AFFECTED TECHNICAL SPECIFICATION PAGES
(NUREG-1468)

(Pages iii, 2-1, 2-2, 2-3, 2-5, 2-6, 2-9, 2-10, 2-11, B 2-1,
B 2-5, 3/4 1-1, 3/4 1-3, 3/4 1-8, 3/4 1-10, 3/4 1-13, 3/4 2-12,
B 3/4 1-1, B 3/4 1-2, B 3/4 1-3, 6-20, 6-21, 6-21a)

ENCLOSURE 1 TO TXX-95076

GENERIC LETTER 88-16 - REMOVAL OF CYCLE-SPECIFIC PARAMETER

FIGURE 2.1-1b
UNIT 2 REACTOR CORE SAFETY LIMITS

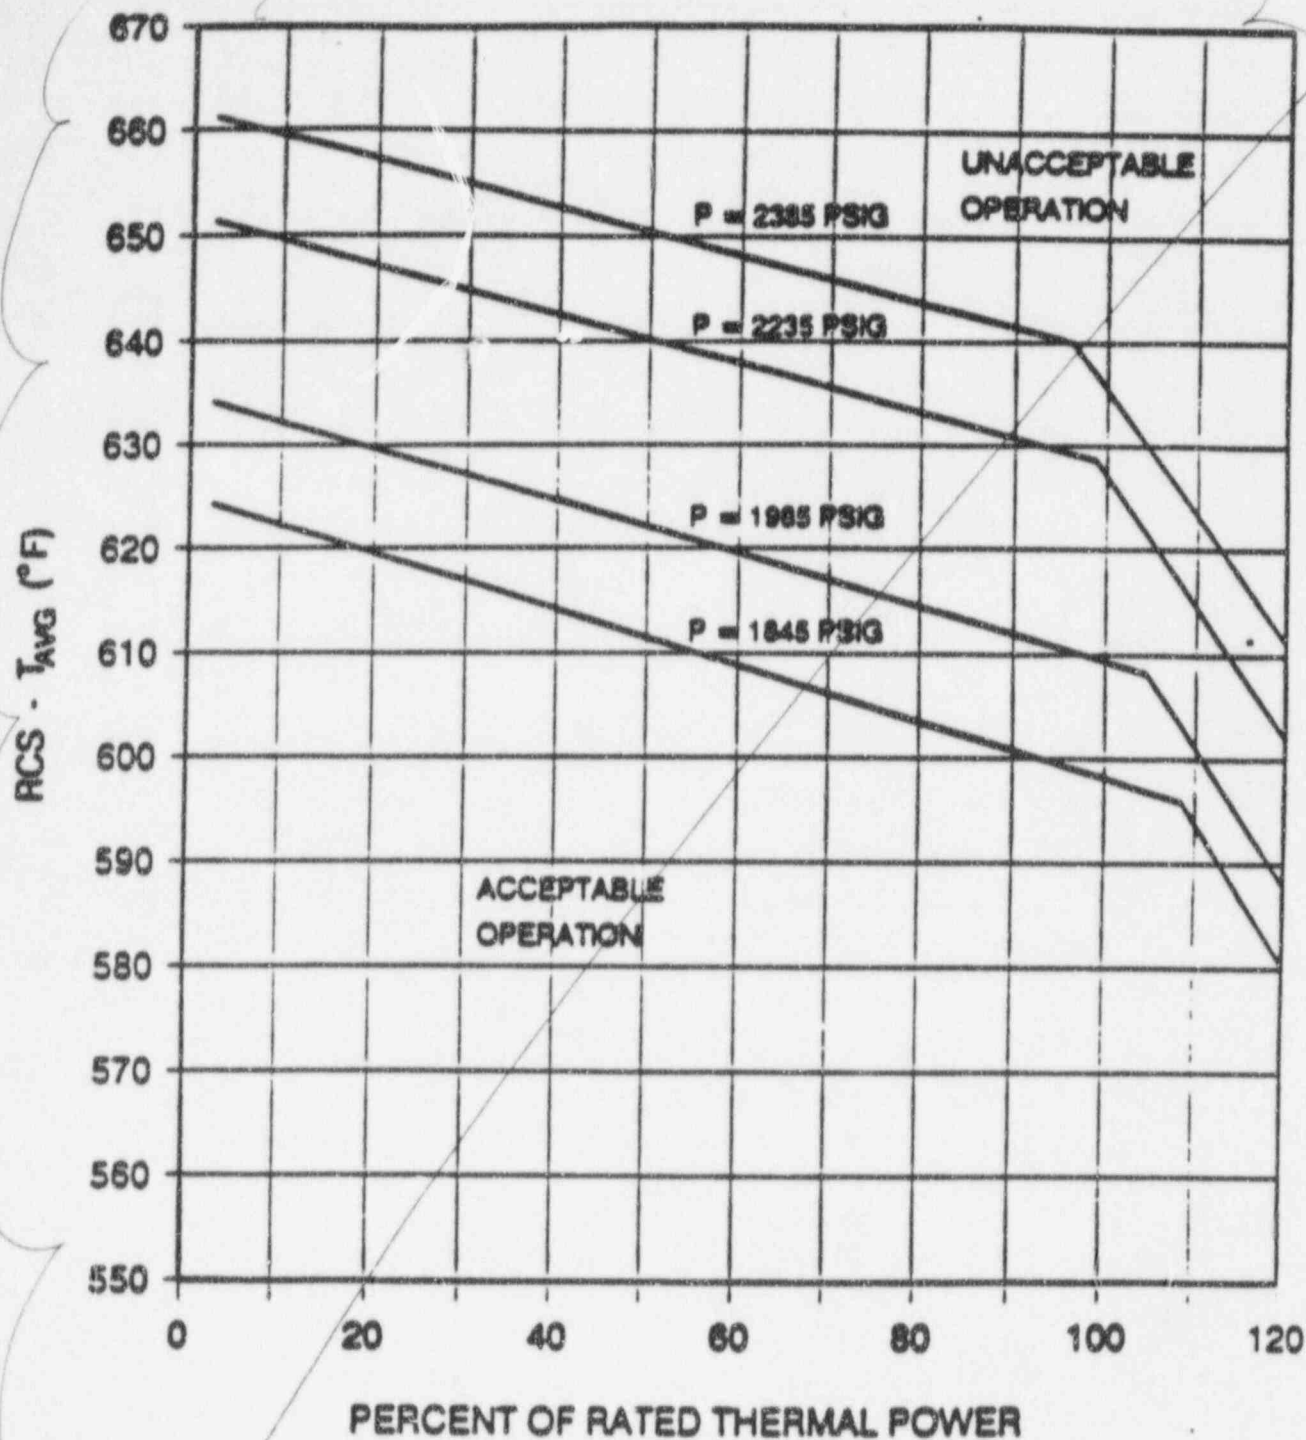
Delete

FIGURE 2.1-1a
UNIT 1 REACTOR CORE SAFETY LIMITS

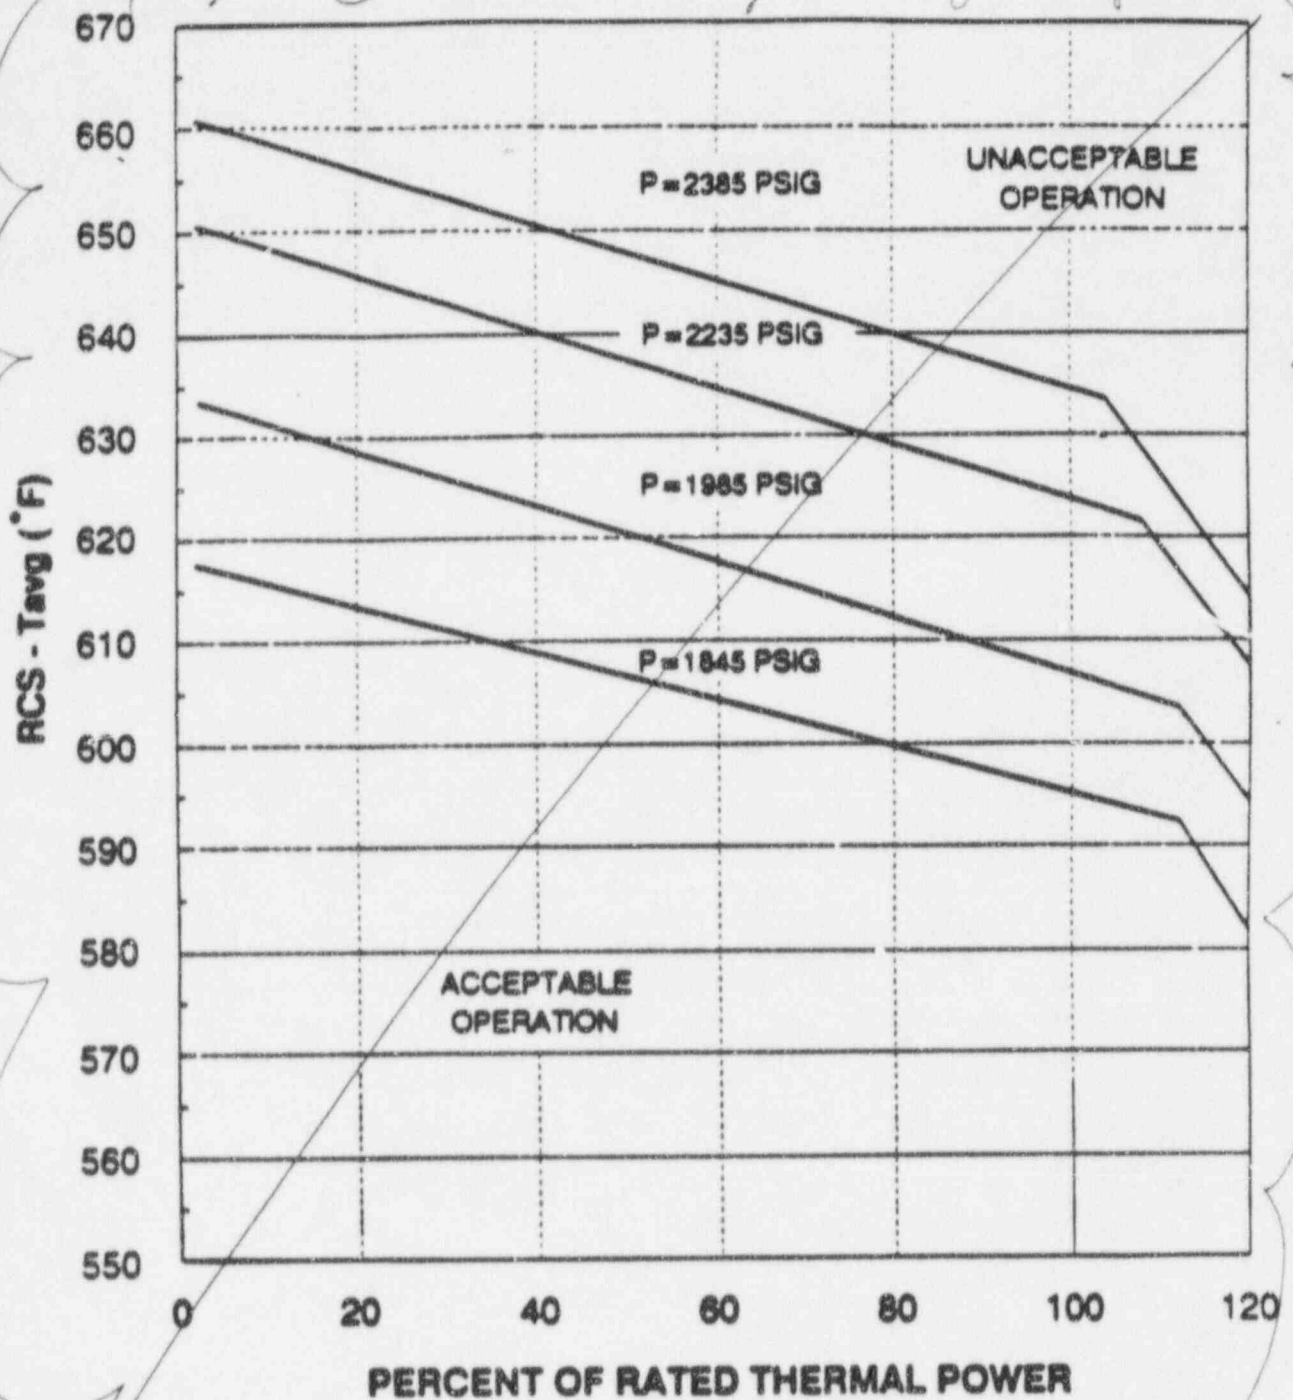
2.1.1 The combination of THERMAL POWER, pressurizer pressure, and the highest operating loop coolant temperature (T_{avg}) shall not exceed the limits shown in ~~Figure 2-1-1~~ *the Core Operating Limits Report (COLR)*.

Delete

The curves of ~~Figure 2.1-1~~⁹ show the loci of points of THERMAL POWER, Reactor Coolant System pressure and average temperature below which the calculated DNBR is no less than the safety analysis limit value, or the average enthalpy at the vessel exit is less than the enthalpy of saturated liquid.
